RR8000-HDD TRAY ISSUE

Short term / Long term solution

ME Second round solution 2019/9/23

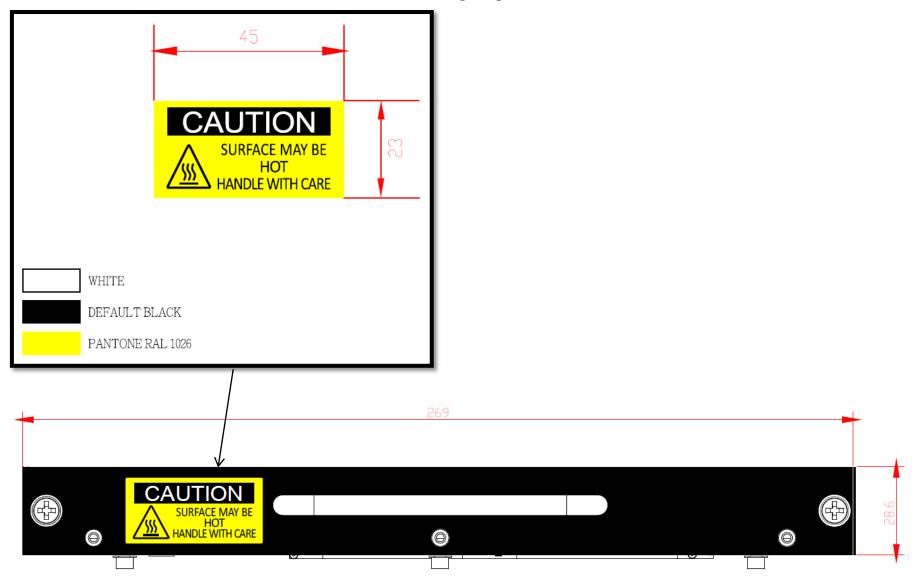
- 1. The simulation result on 9/20's suggestion is failed to meet high temp protection (still very hot).
- 2. Adopting ME Second round solution in next slide shown.
 - Considering to the current mechanical architecture design, the best can do will be adding rubber on handle and front panel (shown in yellow pad)

Adding rubber on the Handle & Adding rubber in front of the panel (outside/ yellow part).

9/25 will acquire the rubber → ME will implement the solution → RA will implement the burn in test 65 °C & Room temp
